PROPOSED SITE PLAN
ST. TAMMANY PARISH OFFICE BUILDING
520 OLD SPANISH TRAIL
SLIDELL, LOUISIANA

RENOVATE OFFICE BUILDING
DAMMON ENGINEERING. INC.
1095 FLORIDA AVENUE 985-649-5832 SLIDELL, LA. 70458
DAMMONENGINEERING.COM

SCALE: 1" = 20'
FILE:
JOB NO. 1729
DATE: 1-8-07
SHEET
C-3
OF

ADDENDUM 2 REVISED: 08-20-07/ab
REVISED: 03-01-07/ab
REVISED: 02-27-07

SITE PLAN

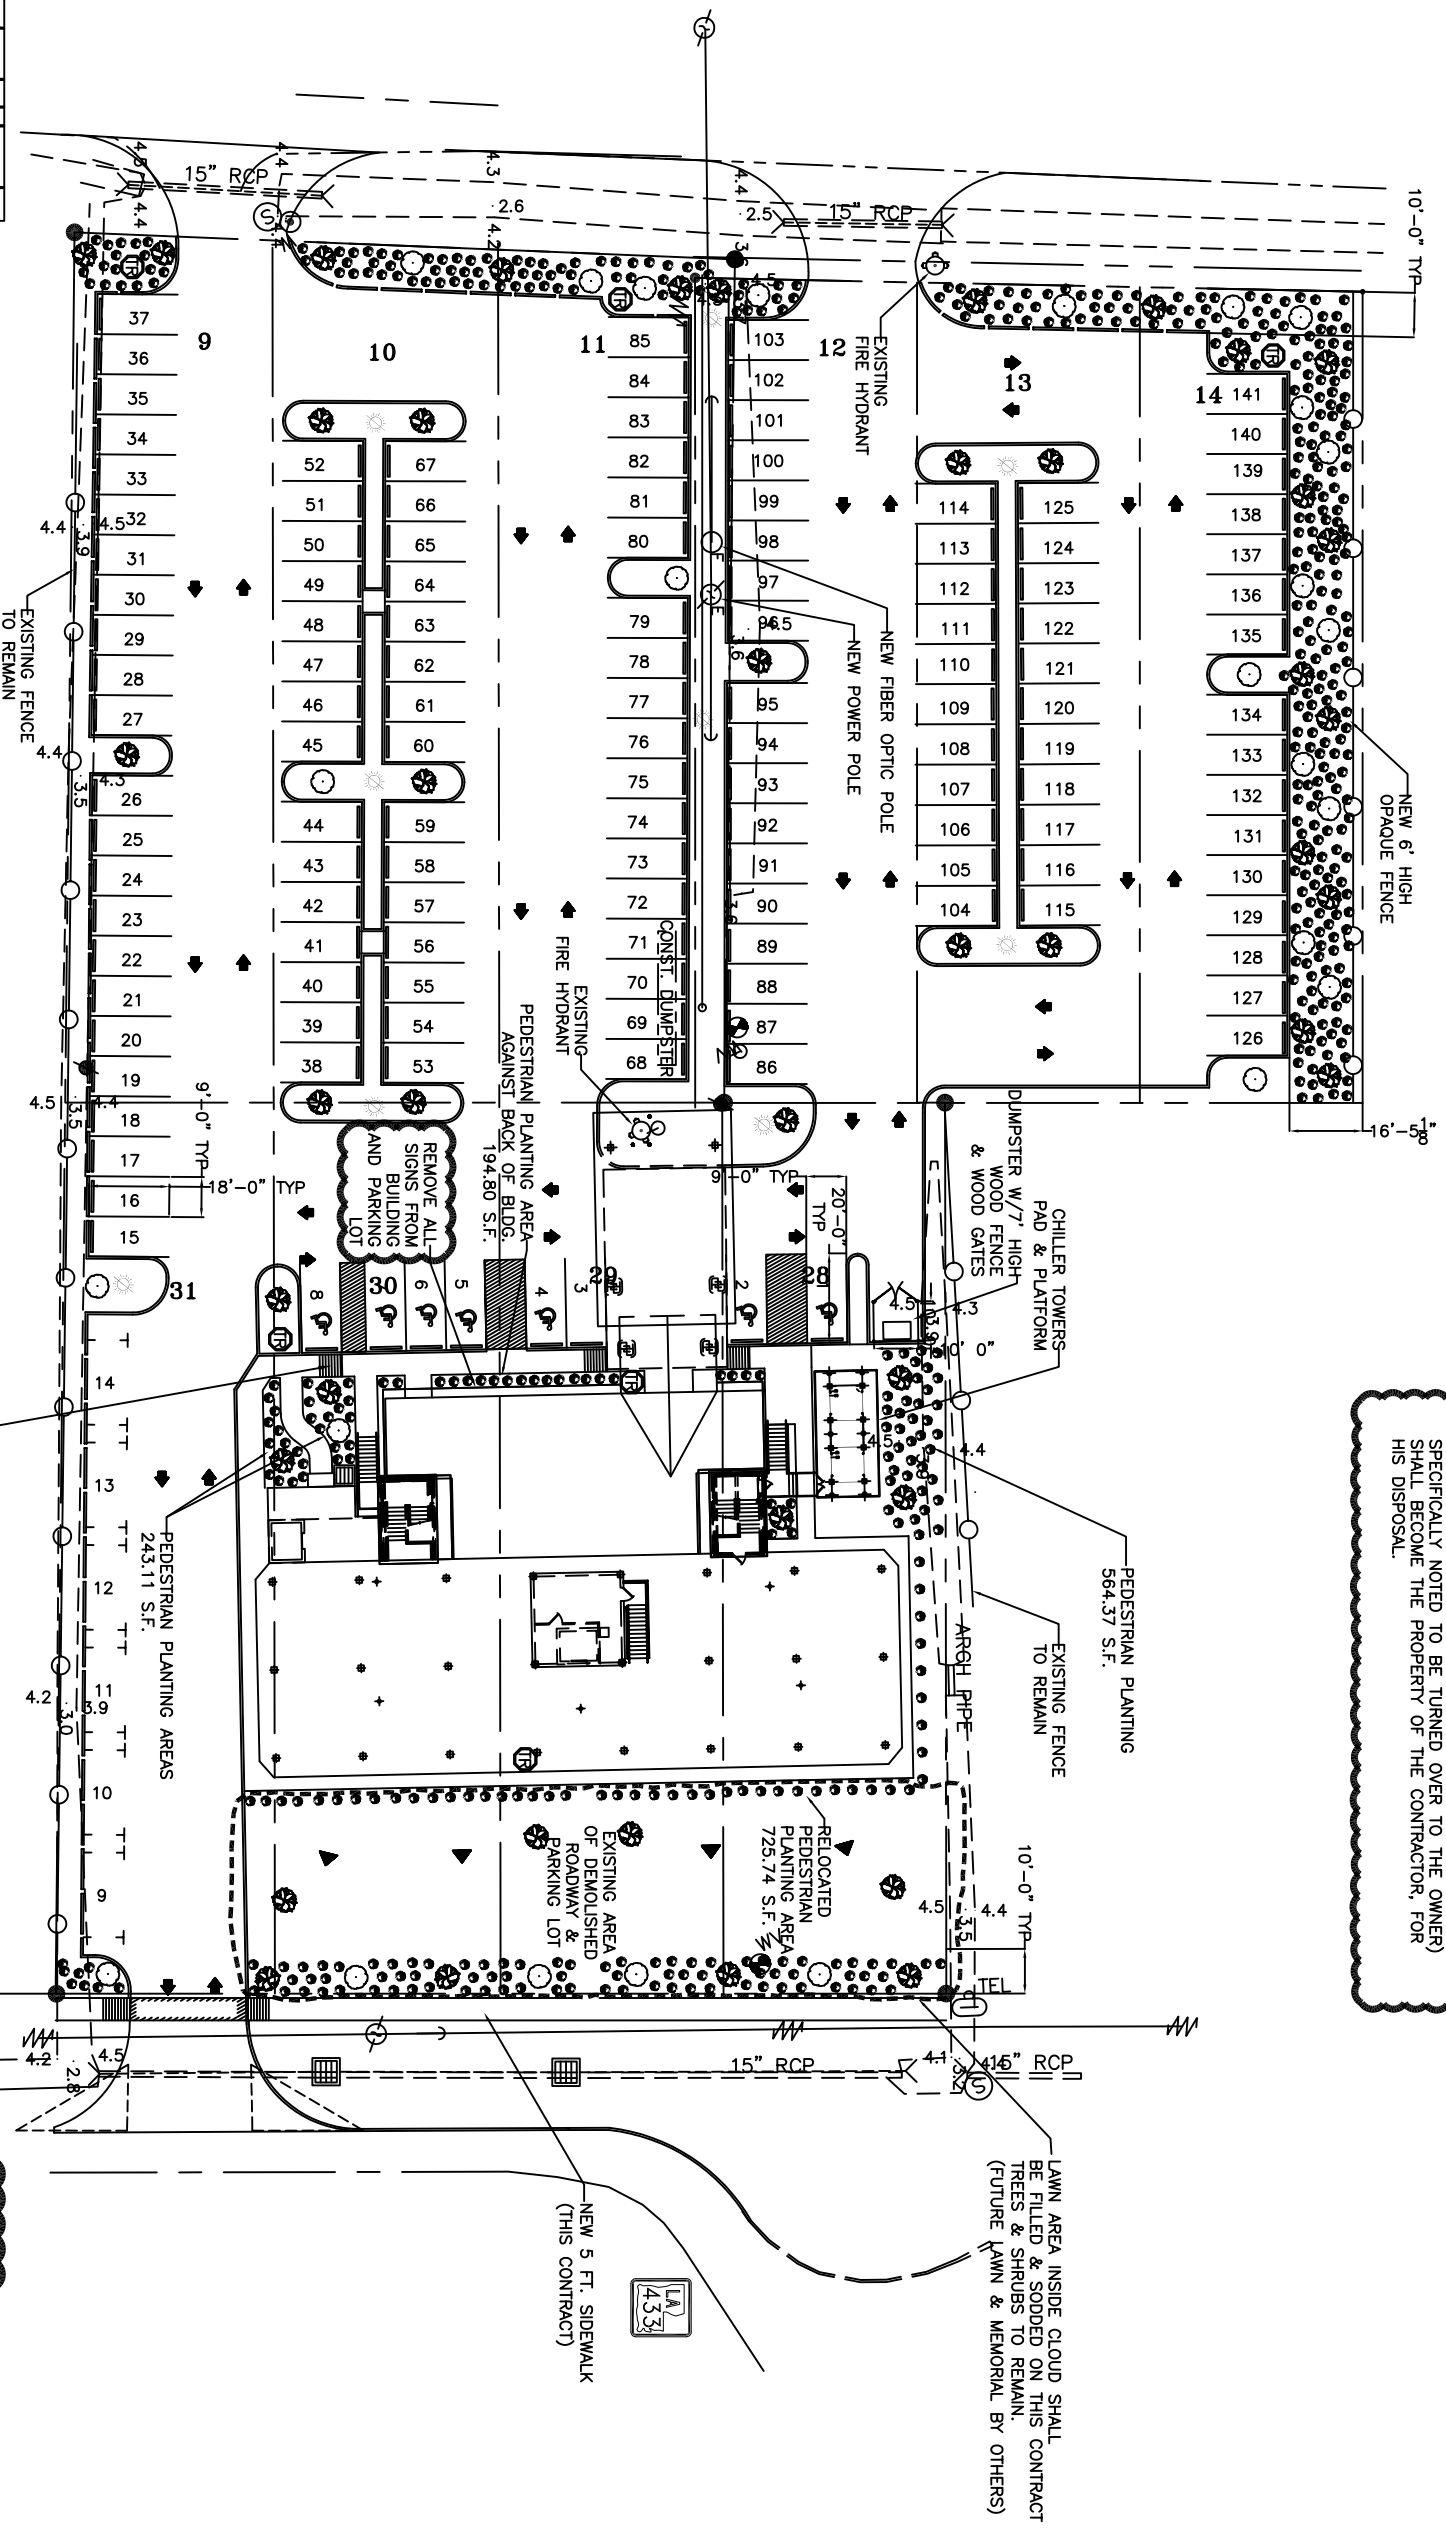
ADDENDUM 2 CHANGE

LAWN AREA INSIDE CLOUD SHALL BE FILLED & SODDED ON THIS CONTRACT. TREES & SHRUBS TO REMAIN. (FUTURE LAWN & MEMORIAL BY OTHERS)
